TITLE: [PR-CM] Development Application DA13/0175 for an 83 Lot Residential Subdivision in Four Stages Comprising 79 Residential Lots with Dedication of Two Lots as Drainage Reserves, One Lot as Public Reserve and One Lot as Sewer Pump Station Site at Lot 332 DP 1158142 Silkpod Avenue, Murwillumbah

FILE REFERENCE: DA13/0175 Pt3

This development application is being reported to Council as it is a subdivision that creates more than 50 lots. The development application was lodged on 17 April 2013.

Figure 4: excerpt of final subdivision plan 19291 B Sheet 1 Revision E (19 November 2013)

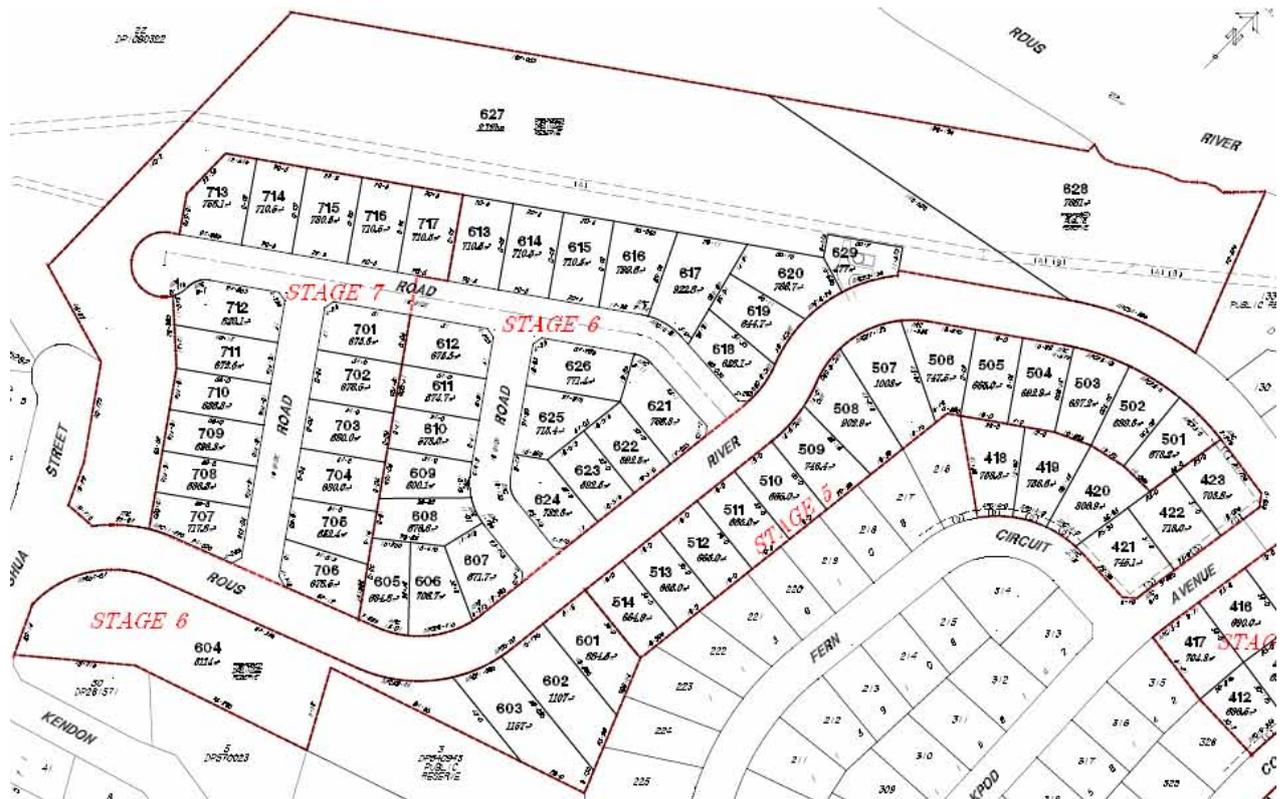
- Failure of the applicant to satisfactorily resolve stormwater drainage issues for the outlet from Frangella Park (within proposed Lot 604);
- Inability for Council to accept dedication of Lot 604 without appropriate drainage improvements;
- An unacceptable impact on, and unwarranted risk to an identified threatened species (Grey-headed Flying Fox colony and associated habitat); and
- The cumulative effect of Council accepting multiple less-than-ideal elements of the proposal that result in substantial financial and maintenance responsibilities into the future.

The amended proposal incorporates a revised layout adjacent to Frangella Park (Lots 601, 602 and 603), renumbering of allotments and other consequential amendments.

Figure 5: land affected by 1990 TPO (purple area denotes TPO within Lot 332)

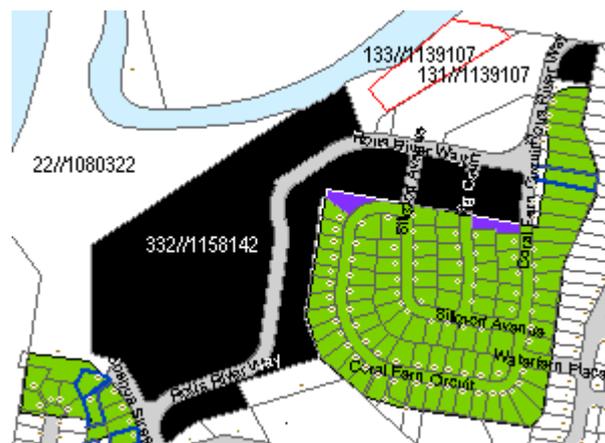
The subject site is affected by the 1990 Tree Preservation Order (TPO). The 1990 TPO affects a small portion of existing Lot 332. No vegetation is proposed to be removed within this portion. As such, the proposal is consistent with this clause.

Figure 6: land/waterbody affected by Key Fish Habitat

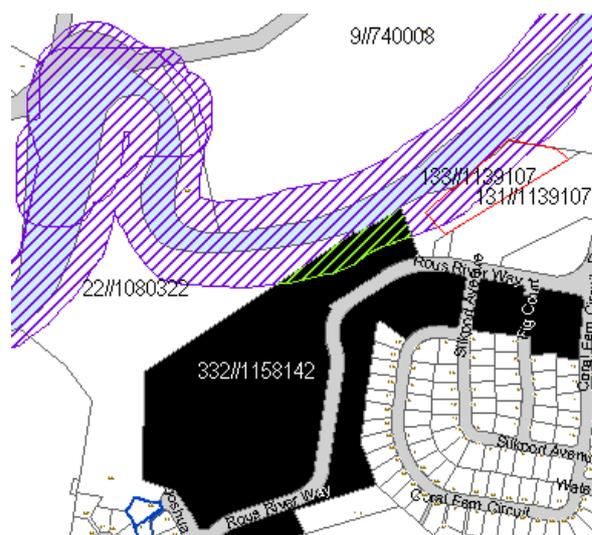
The area of land adjacent to the Rous River (where the drainage channel is to be located) and the river itself is considered to contain key fish habitat.

Unsatisfactory provision of drainage management within this area is likely to reduce the quality of the existing habitat. At the very least, Council must ensure that native vegetation surrounding the fishery habitat area is conserved.
